Item Name: Crosstube Turning Detail

DART AEROSPACE LTD		Work Order: 116470
Description: Crosstube Assembly (205/212/412 High Fwd)		Part Number: D212-664-141
Inspection Dwg: D212-664-141 Rev: D		Page 1 of 2

DRAWING NO. D212-664-141	TITLE XTUBE ASSY (205/212/412 HI FWD)	REV. D	DART AEROSPACE LTD ENGINEERING ORDER		D.E.O. NO. D212-664-141-D-1	SHEET NO. SHEET 1 OF 2	SCALE NTS
DRAWN	CHECKED	MFG. APPR.	APPROVED	DE APPR.	DATE	DATE	DATE
DATE 11.04.07	DATE 11.07.11	DATE 11.04.12	DATE 11/04/12	DATE 11.04.12	DATE 11.04.12	DATE 11.04.12	DATE 11.04.12

DRAWING NO. D212-664-141	TITLE CROSSTUBE ASS'Y (205 HI FWD)	REV. D	DART AEROSPACE LTD ENGINEERING ORDER		D.E.O. NO. D212-664-141-D-2	SHEET NO. SHEET 1 OF 1	SCALE NTS
DRAWN <i>UP</i>	CHECKED <i>AJS</i>	MFG. APPR. <i>AS</i>	APPROVED <i>MD</i>		DE APPR. <i>TH</i>		
DATE 11.07.15	DATE 11.07.20	DATE 11.07.21	DATE 11/07/21		DATE 11.07.21

**D212-664-141/-141B
ASSEMBLY DETAIL**

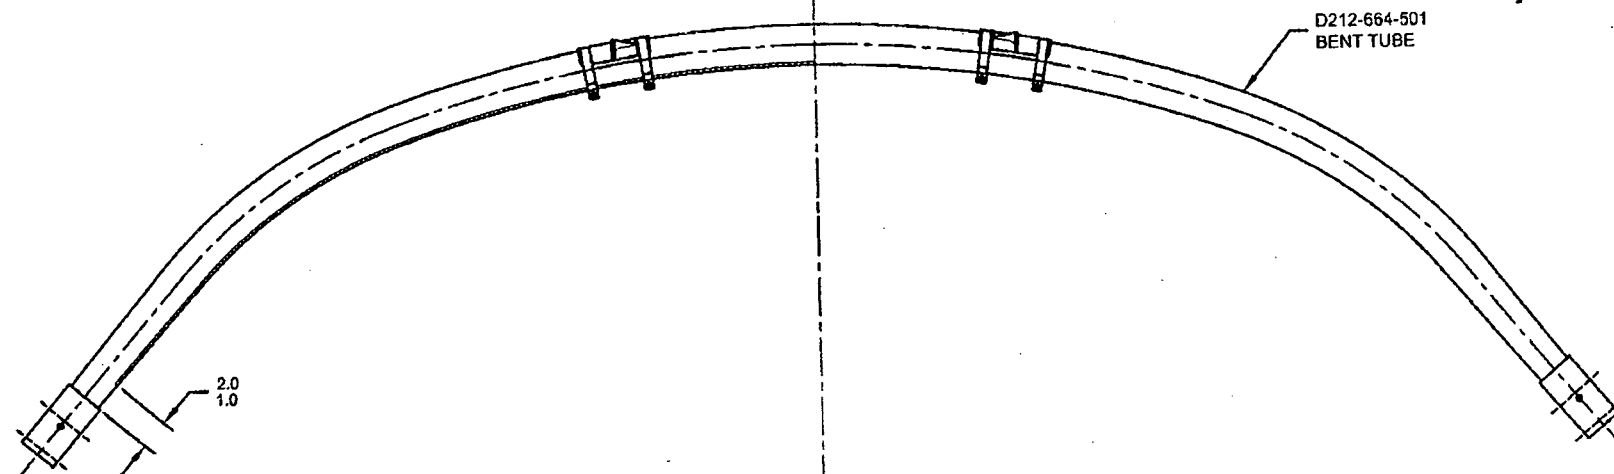
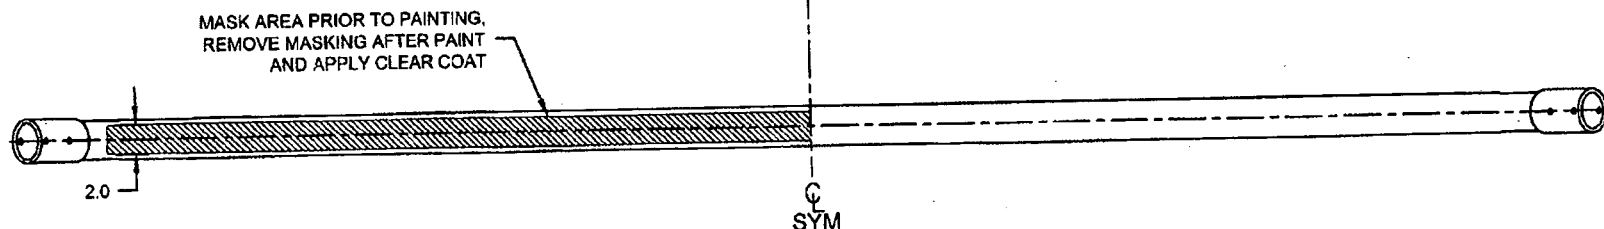
PURPOSE:

ADD AN INSPECTION WINDOW TO UNDERSIDE OF CROSSTUBE.

NOTES 2 OF SHEET 1 IS AMENDED AS FOLLOWS:

IS:

- 2) FINISH: CHEMICAL CONVERSION COAT PER DART QSI 005 4.1
PRIME INSIDE AND OUTSIDE PER DART QSI 005 4.2
MASK UNDERSIDE OF CROSSTUBE AS SHOWN (HATCHED AREA) AND
PAINT OUTSIDE PER DART QSI 005 4.2
REMOVE MASKING AND APPLY CLEAR COAT

WAS:

- 2) FINISH: CHEMICAL CONVERSION COAT PER DART QSI 005 4.1
PRIME INSIDE AND OUTSIDE PER DART QSI 005 4.2
PAINT OUTSIDE PER DART QSI 005 4.2
